Memorandum

To	Michael Czarnecki		
Copy to	[REDACTED]		
From	[REDACTED]	Tel	(07) 3316 3000
Subject	Webber Esplanade revetment wall	Job no.	[REDACTED]

COOK SHIRE COUNCIL
WEBBER ESPLANADE
REVTMENT WALL AS-BUILT
DESIGN CHECK - SHEET 1 OF 2

COOK SHIRE COUNCIL
WEBBER ESPLANADE
REVTMENT WALL AS-BUILT
SECTION REVIEW - SHEET 6 OF 6

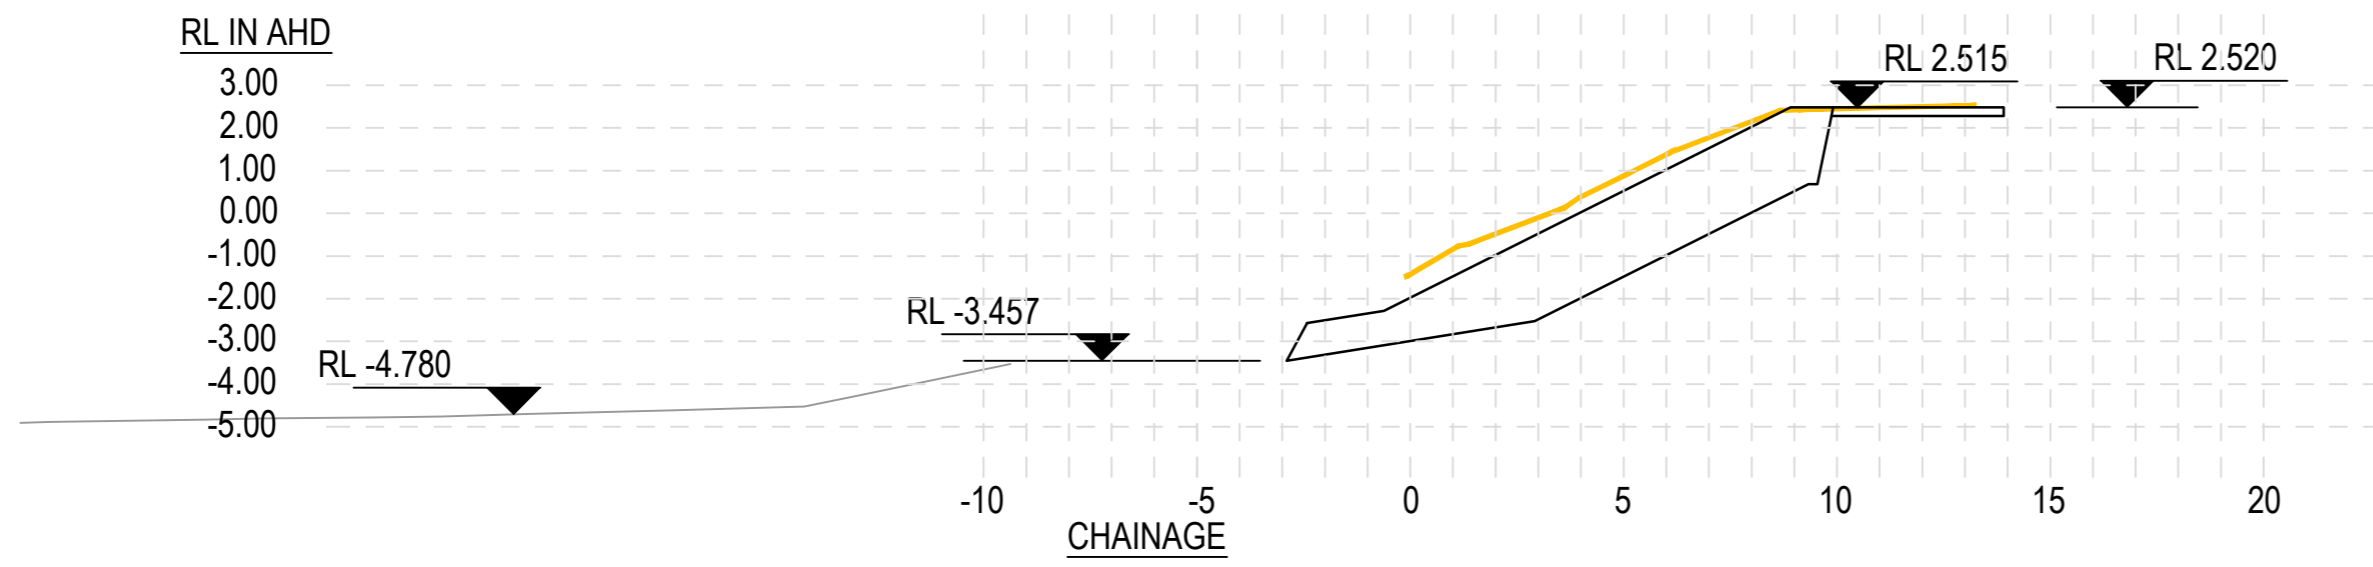
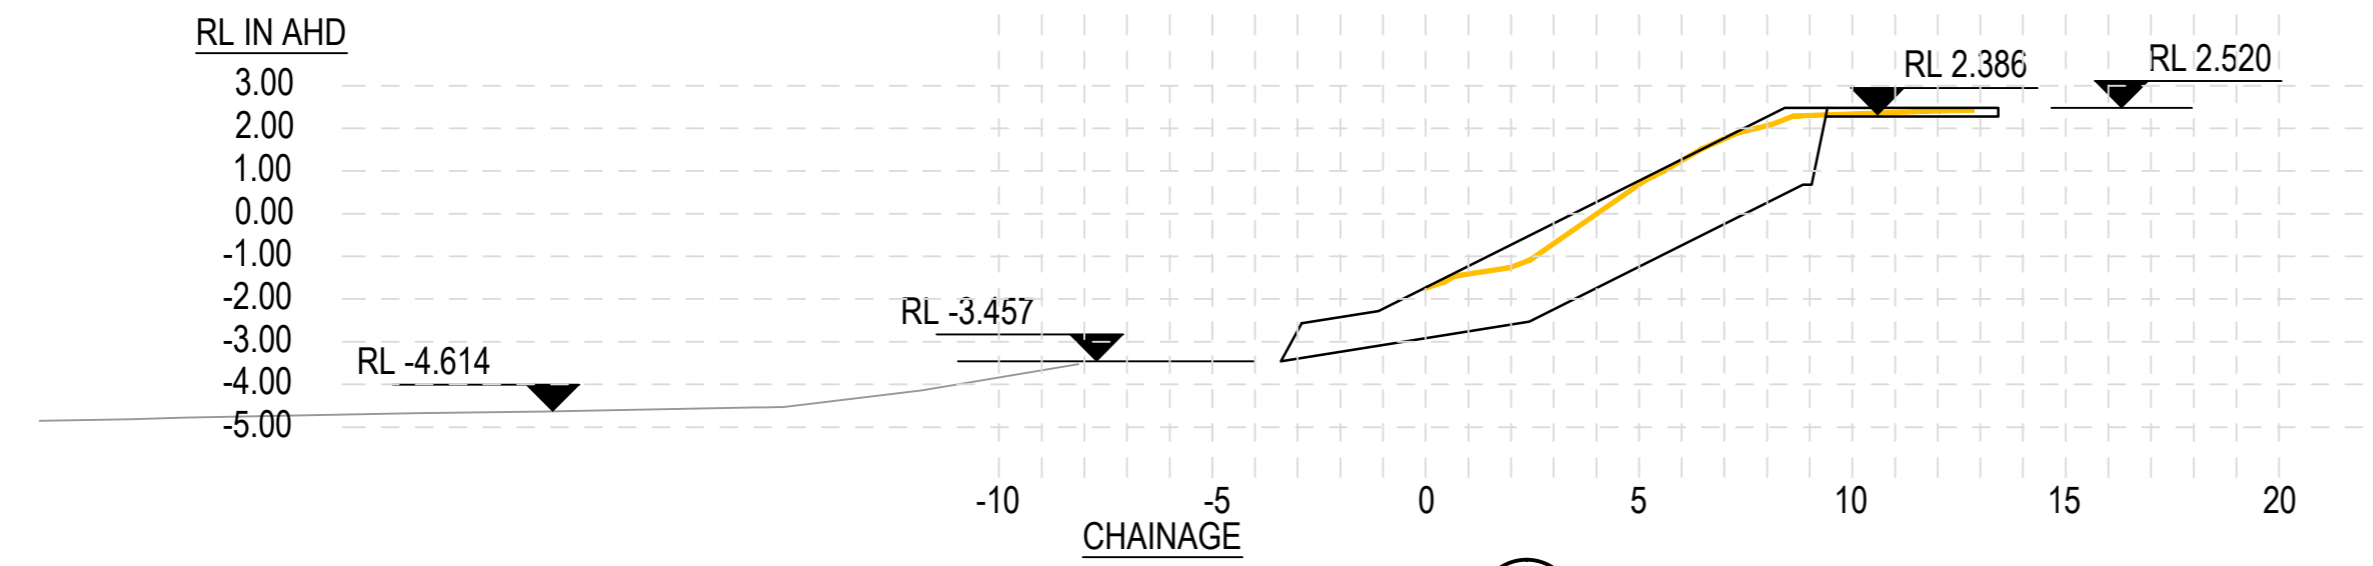
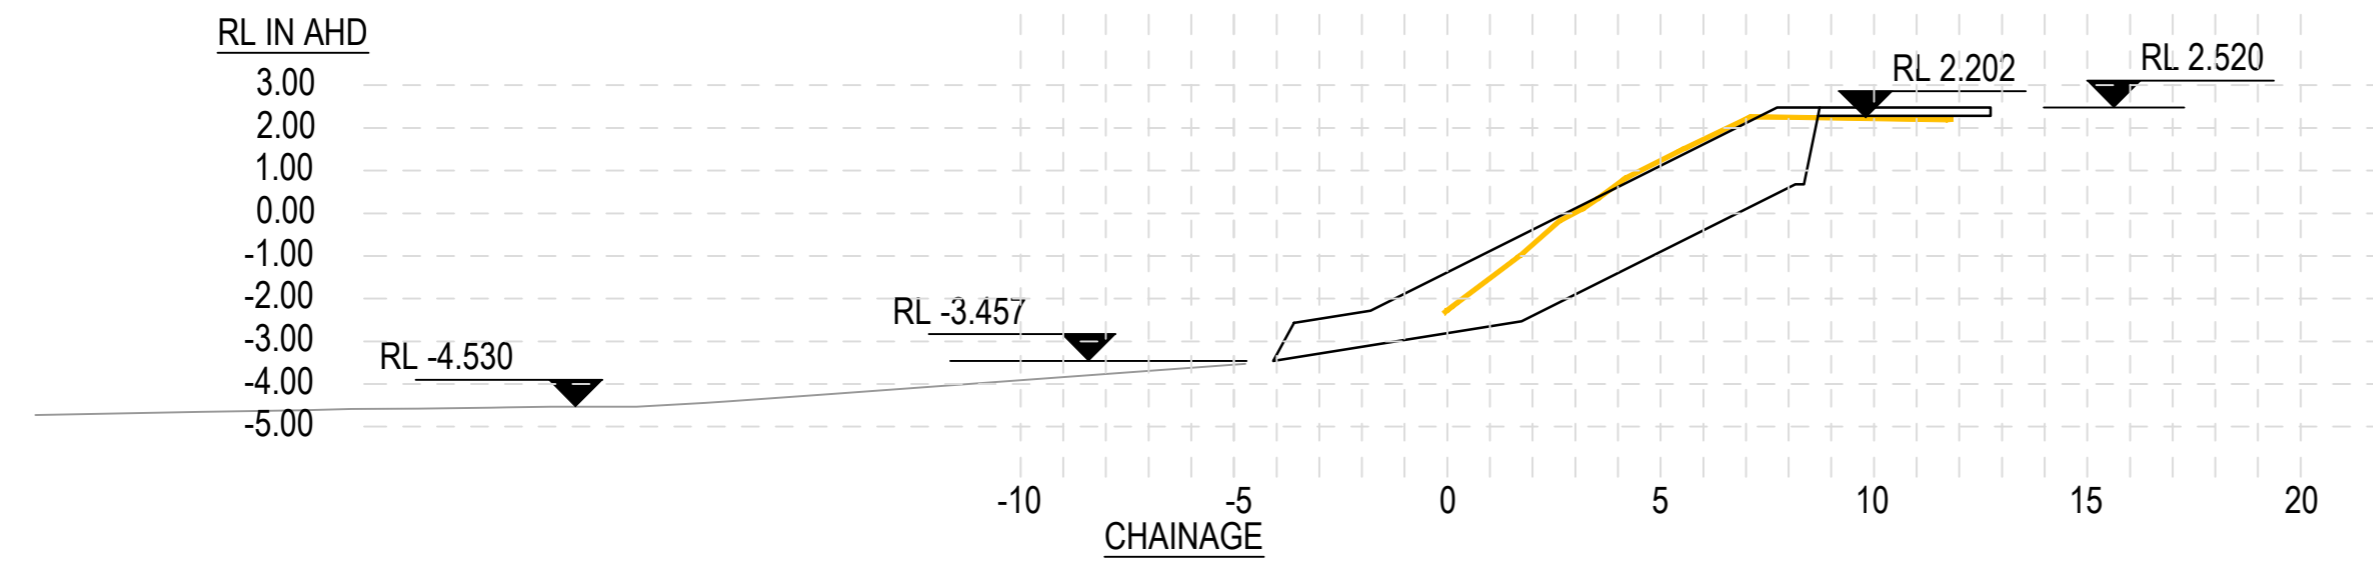
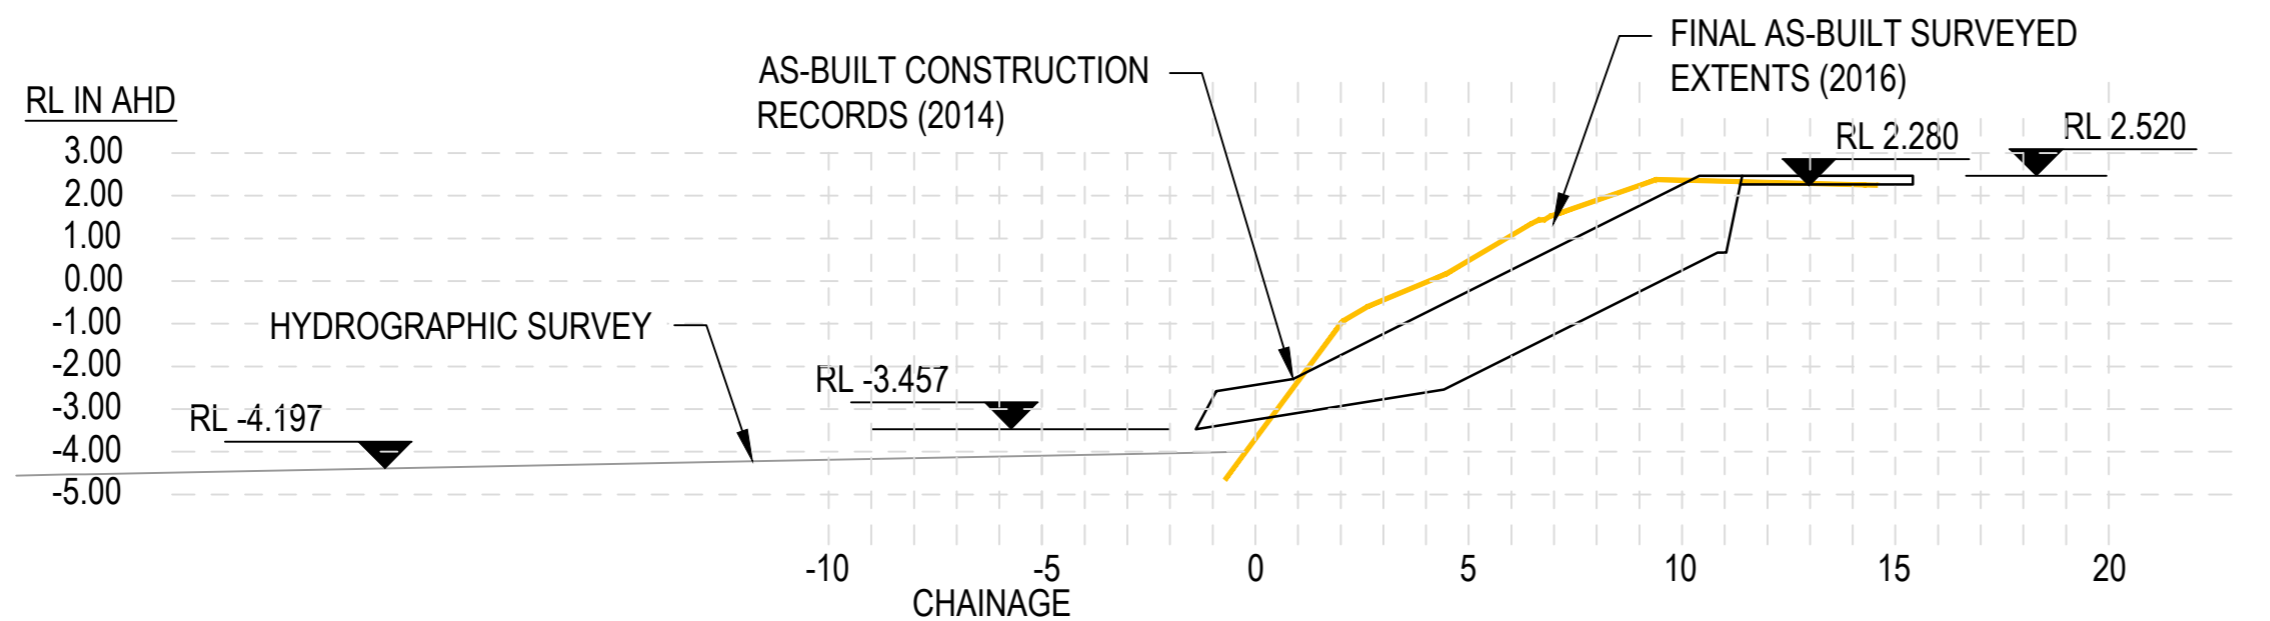
- The constructed slope is somewhat variable, with sections slopes 1, 2, 3, 4, 5, 6, 7, 8, 9, 10, 11, 12, 13, 14, 15, 17, 18, 19, 21 and 24 generally flatter than the design slope of 1 vertical to 2 horizontal.
- Section 20, 22, 23 have a steeper slope than the design slope of 1 vertical to 2 horizontal.
- For the majority of sections, the rock toe is not clearly distinguishable compared to the design profile.
- It is noted that complete survey coverage over the complete design profile, has not been provided in sections 22, 23 and 24.
- Survey of the seabed has not been provided. To aid further investigation, survey of the seabed is recommended.

The 'as-constructed' survey shows that the crest level, for most sections in attached 41-29566 SK-001 to SK-008, has generally been constructed above the design level of +2.52 m AHD. Sections 21 through to 23 show a finish level slightly below the design level of +2.52 m AHD.
